APPENDIX G

Public Hearing Extension Requests and On-Site Responses

Re: Public Notice (07-01) Public for Preserve Marina Owners Assn Inc...
 Proposed (boat ramp), boat docks, slips, pier, etc. Pickwick, Tennessee

Project Name: Public Notice 2/24/07 Sites on river - Hawk Branch, Pickwick

TVA & COE JOINT SITE VISIT TO HAW BRANCH COVE

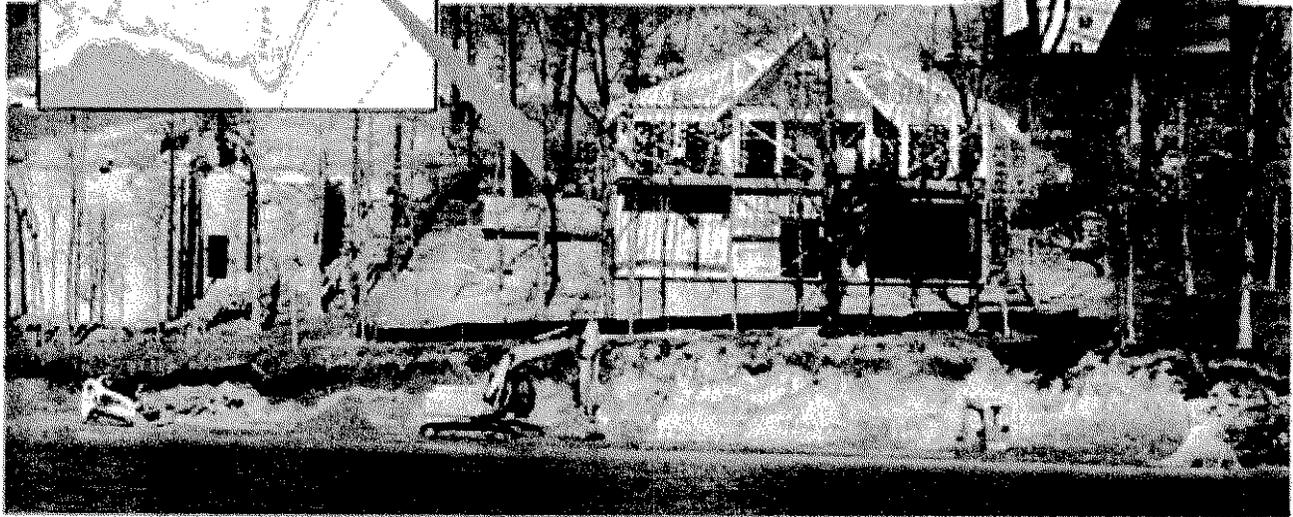
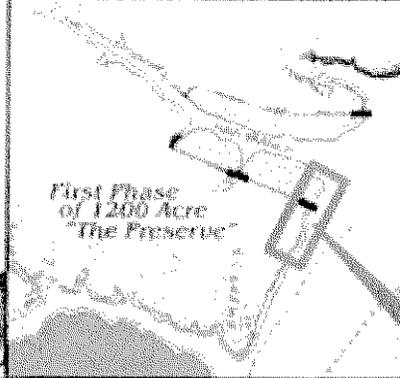
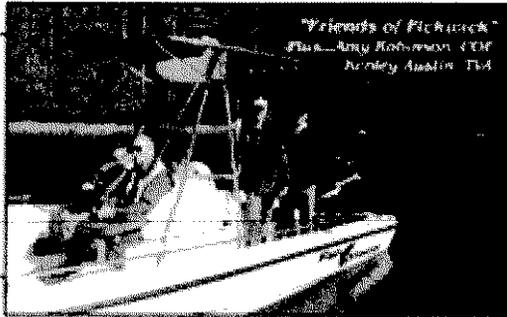
During site visit to nearby Haw Branch cove with TVA & Corps reps, Friends of Pickwick shot these photos of showing serious erosion control violations. Since on board officials did not comment on these situations, we assumed this was in TDEC permit jurisdiction. Now we hear otherwise. Please explain what is going on here. We know TDEC official spent all day Friday on sites, but are other agencies & permits also involved? If so, what, when, where, who and why?

What permits or role do TVA and/or Corps officials play here? In lieu of serious water quality degradation issues here, was a 'cease and desist' order issued...and what kind of new erosion control measures were established...by who? What is scope of project (over into public land)?

2.22.07 ACTUAL
LOCATION OF
200 ft Boat Ramp

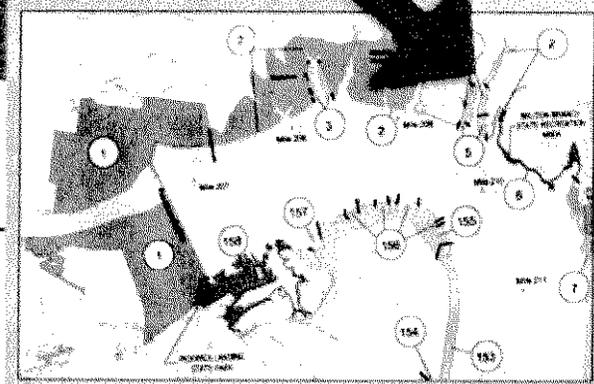
Serious New 'Boat Ramp' Issues: Request to Revoke TVA 26a Permit

TVA 26a Regs. Section 2. This permit may be revoked by TVA by written notice if: (a) the structure is not completed in accordance with approved plans. (e) TVA finds the structure has adverse effect on...public lands... (also other regs per erosion controls, etc)

ALSO, IS NEW RAMP
BUILT ON PRIVATE
OR PUBLIC LAND?

Who authorized approvals
and relocation of boat ramp?
When? Did COE concur?

Under Const (with no erosion controls, plus... questions per location of TVA vs. private land, adverse effect on public land, environmental consequences aquatic habitat, water quality, boating recreation and safety issues)

And, as noted previously, permit for boat ramp should NOT have been fast-tracked or excluded from regulatory/environmental reviews as boat

docks, slips, pier for same project, at same site, by same applicant. PRESERVE MARINA OWNERS ASSN INC. This 'piece-meal' serves the special interests of developers, NOT the public interest. Due to cumulative issues, we now submit formal written request this boat ramp permit be revoked (per "26a" General Conditions" regs. Sections 1, 2a, 2e, 3, 6, 7, 16,) due to permit violations involving altered location of ramp on site (and public land boundary question), violation of state erosion control regulations (and adverse effect on public land/habitat that this ramp either encroaches upon or adjoins).

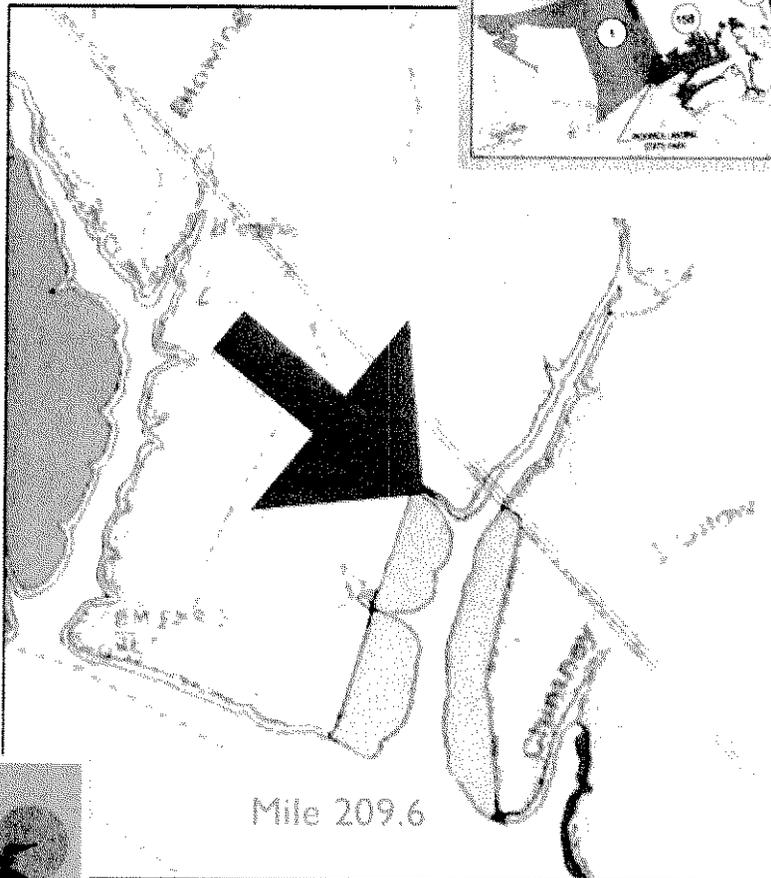
Besides other serious issues with permit and process (details to come), aren't erosion control methods required or other protections for 'waters of the state' on this boat ramp??

PLEASE RESPOND ASAP, WHEN THIS BOAT RAMP WAS STARTED, BY WHO...WHAT APPROVAL(S), FOR CONST AND WHY NO EROSION CONTROLS, ETC. ALSO AT ISSUE IS THE LOCATION, ON PRIVATE OR PUBLIC LAND. INFO TO FOLLOW.

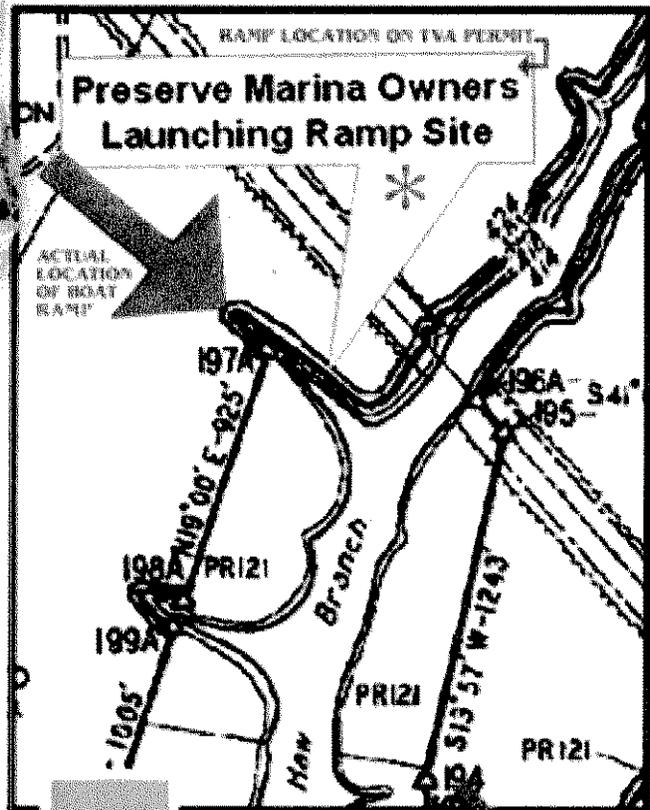
NEW Boat Ramp Issues: (a) During site visit 2/22, TVA rep unaware that boat ramp (for same project still in 'Comment Period'), was ALREADY UNDER CONSTRUCTION... (on same site as proposed boat docks, slips, pier.) See notes below. Also...

(b) BUT...BOAT RAMP NOT AT SAME LOCATION SHOWN BY APPLICANT ON ORIGINAL '26a' TVA PERMIT AP...

* Site Plan Below from TVA File (From our FOIA request rec'd 1/25/07) shows proposed location in middle of small inlet. We challenged validity on 1/16/07, of (CE) exclusion (controversial project with adverse impact on public land), highly questionable 'no dredging' claims...and a 'piece-meal' review process allowing boat ramp to be excluded from SAME environmental reviews as boat docks, slips, pier for SAME site by the SAME applicant!
